TALLAWONG STATION **PRECINCT SOUTH**

ADDENDUM URBAN DESIGN REPORT

Rev. E_10.12.2020

SITE 1B BUILDING HEIGHTS

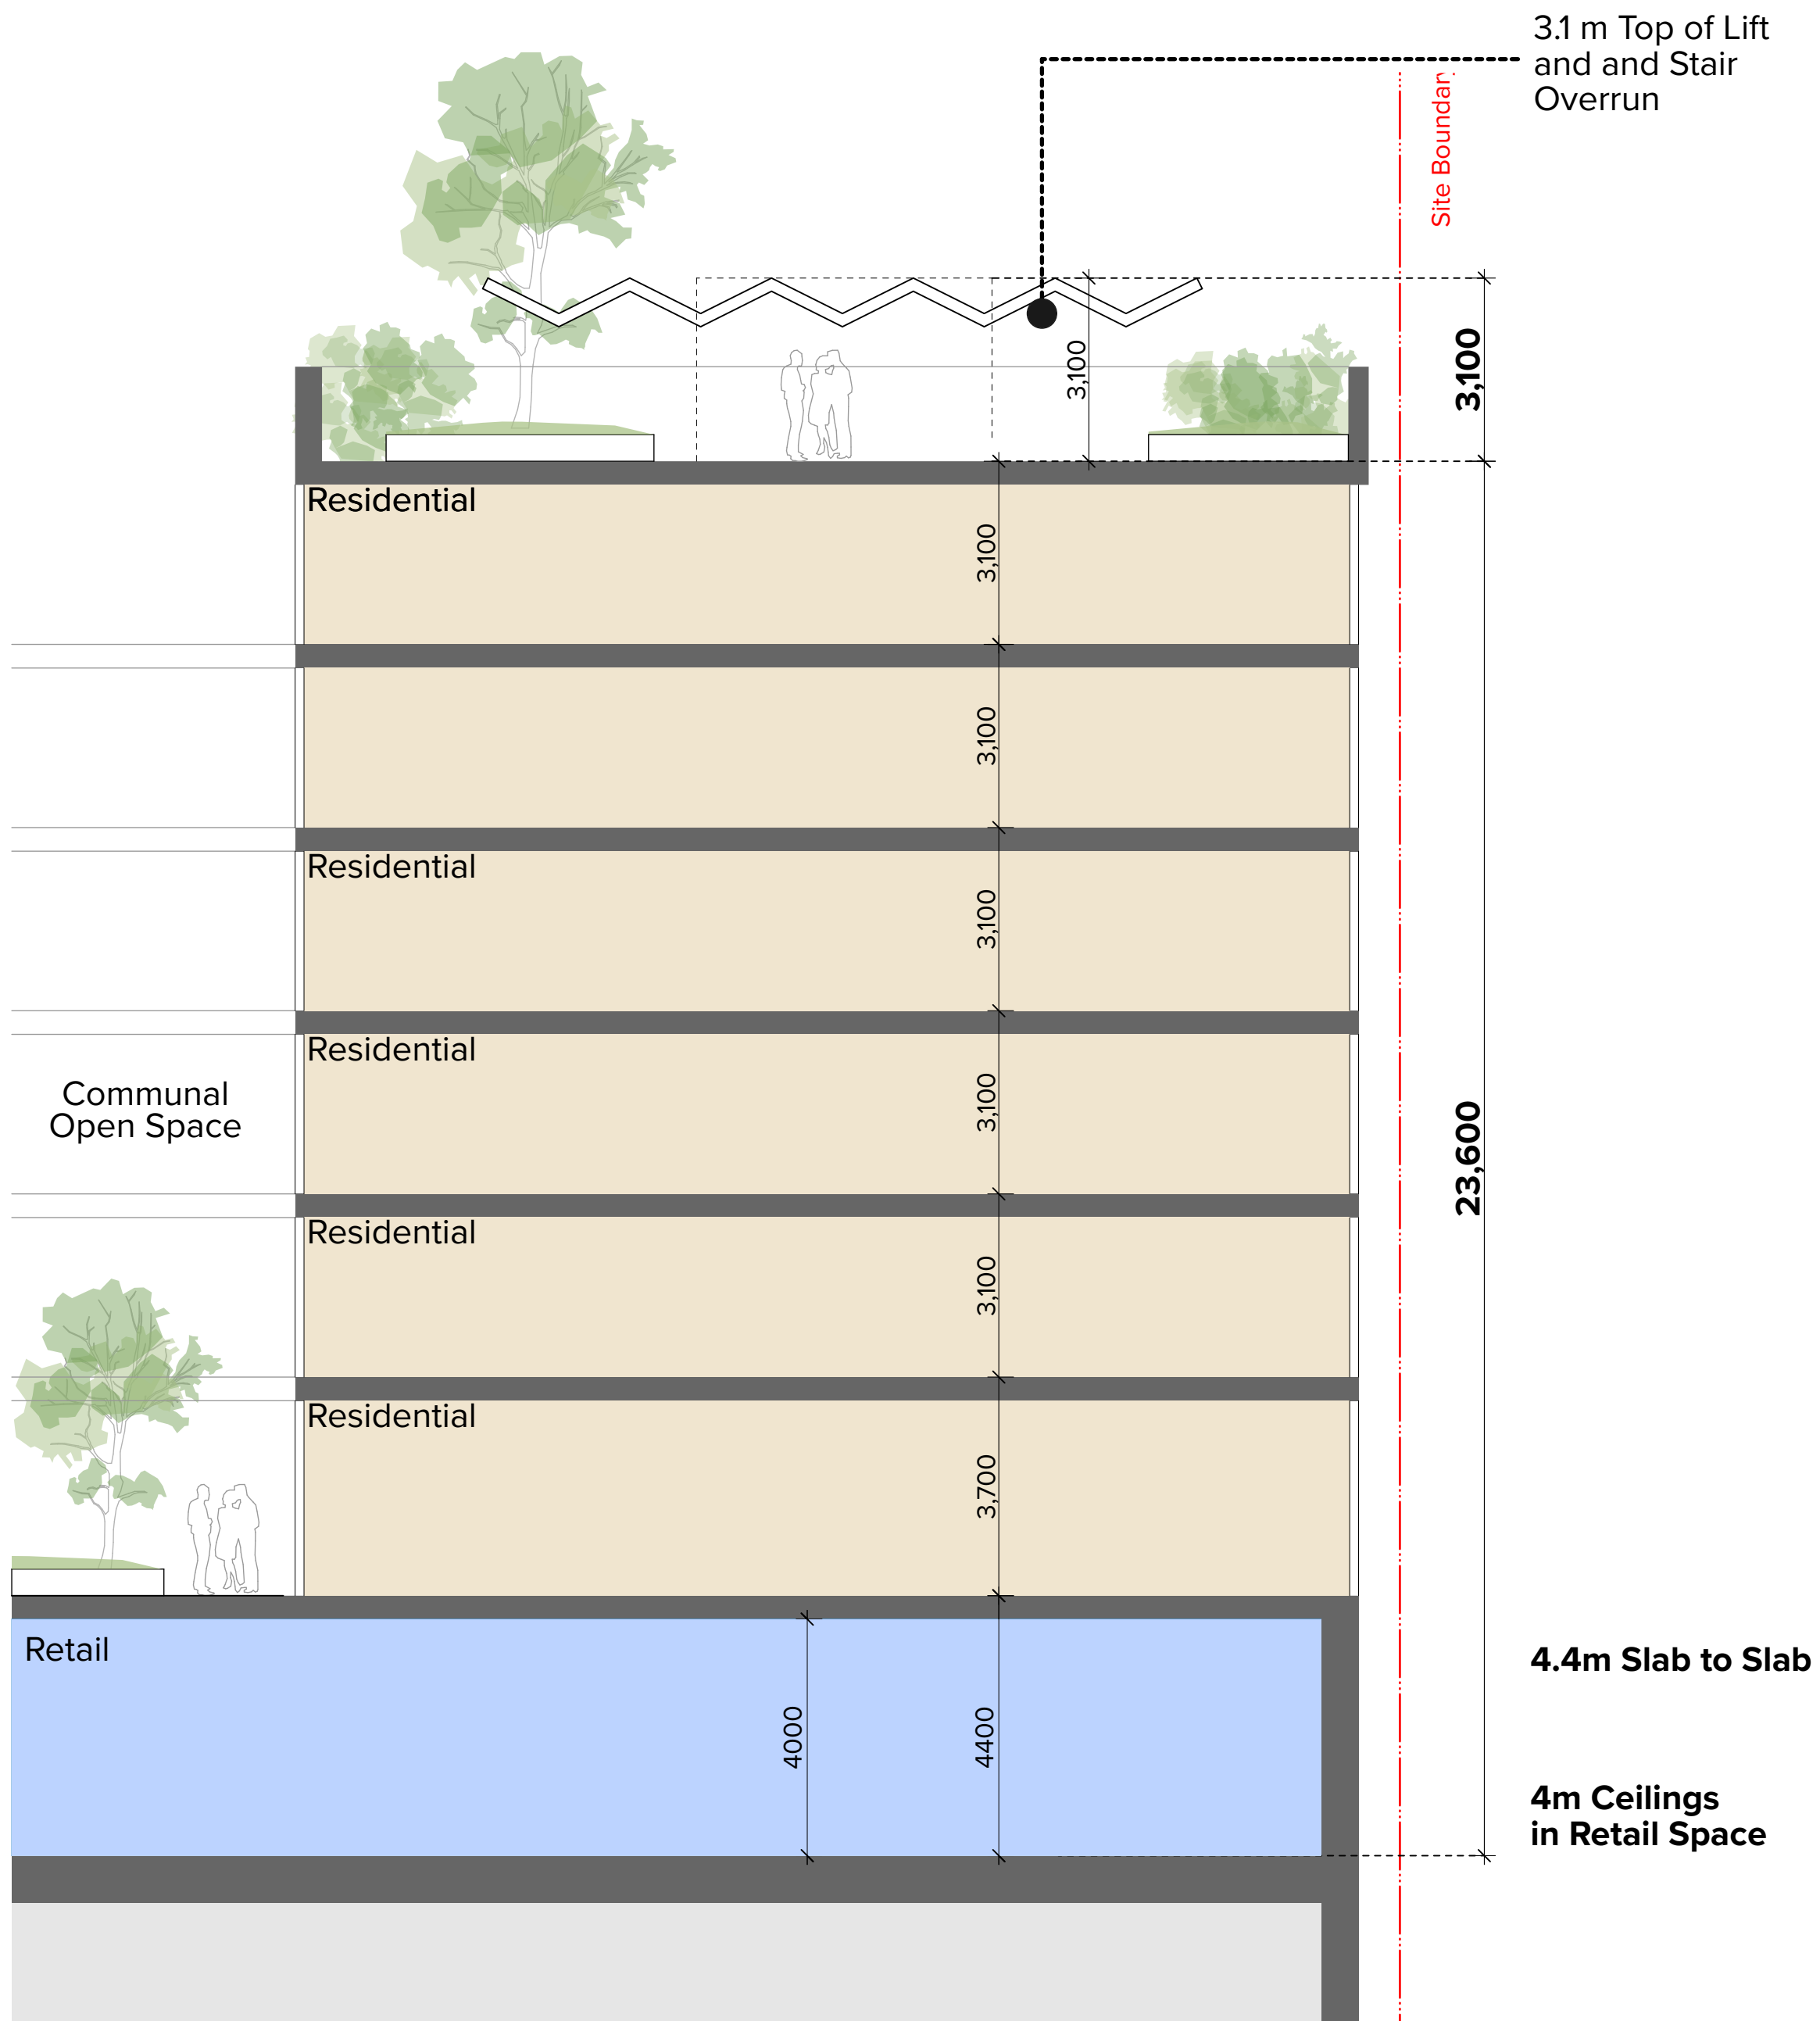
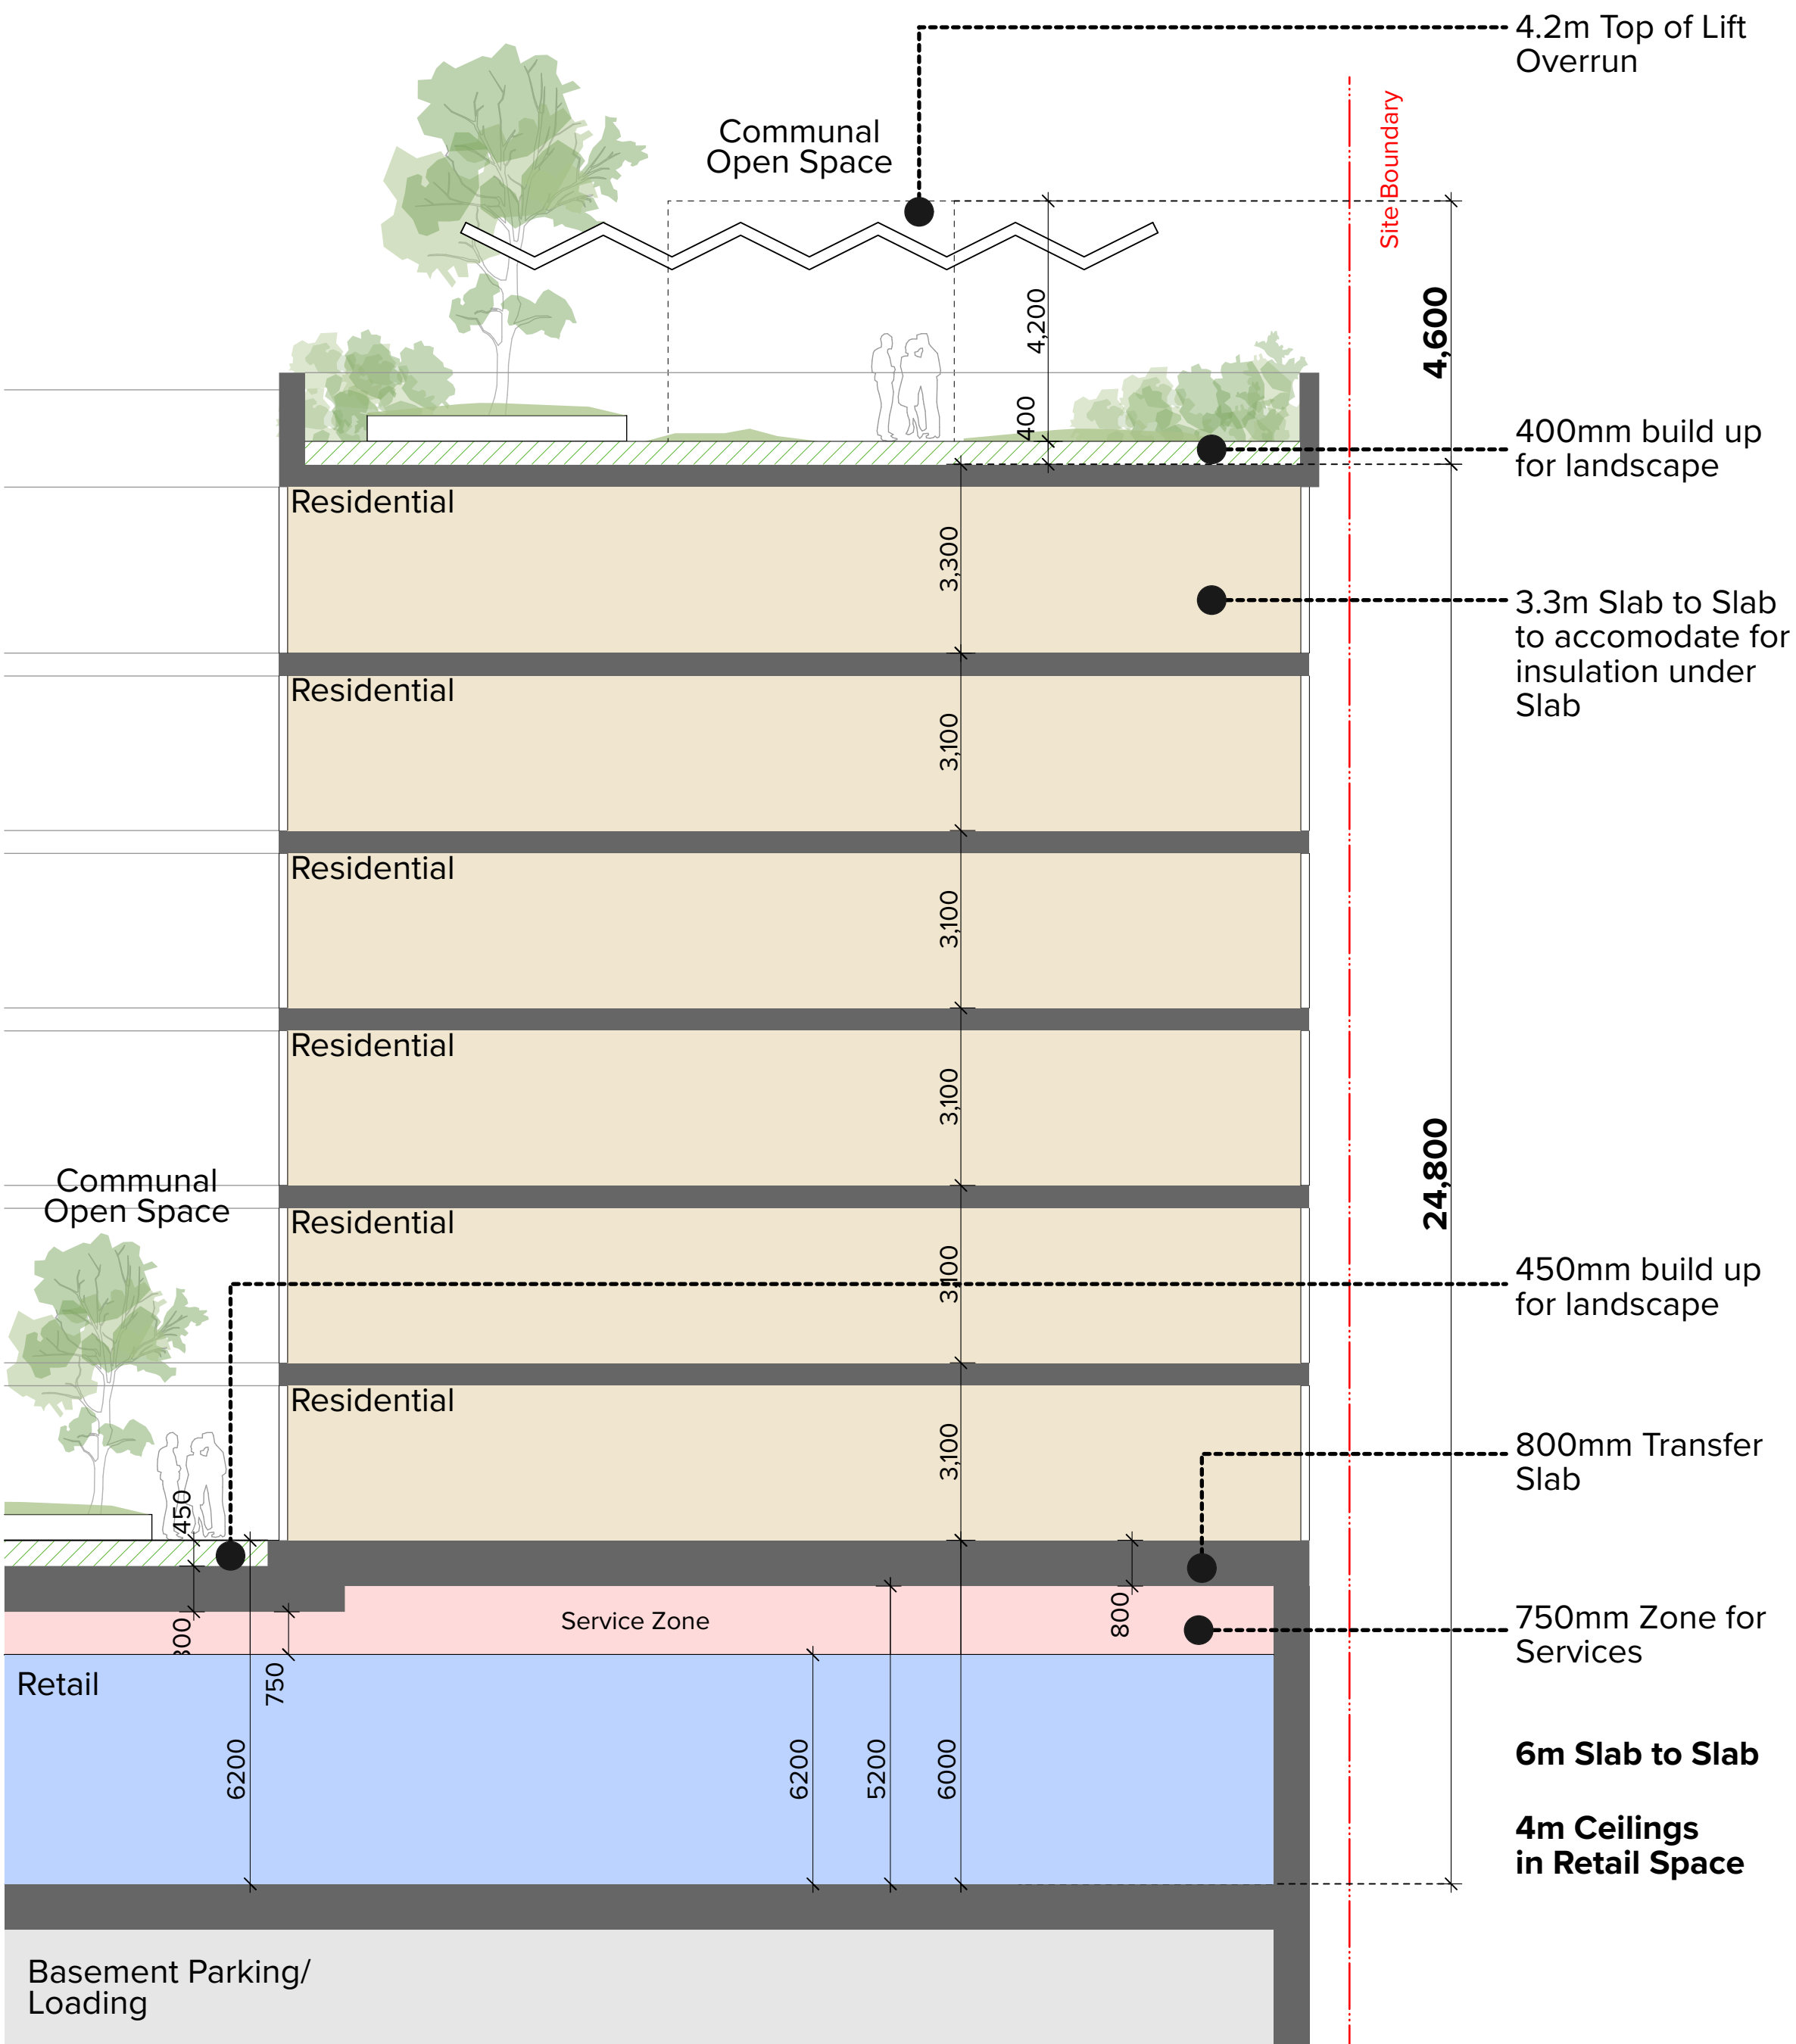
The approved SSDA scheme nominated a 4.0m ceiling height within a 4.4 metre floor to floor height. To accomodate adequate services zones and transfer depths, a floor to floor height of 6.0m is required to achieve a 4.0m ceiling height. This allows for a flexible retail provision that is adaptable to accommodate a number of alternate users over it's life.

Similarly the lift overrun has been assumed at 3.1m above the last level served as opposed to 4.2m which is the average requirement for most lift manufacturers.

These modifications to allow sufficient servicing, circulation and activation of the building marginally increases the heights of the buildings on the primary retail Site 1B.
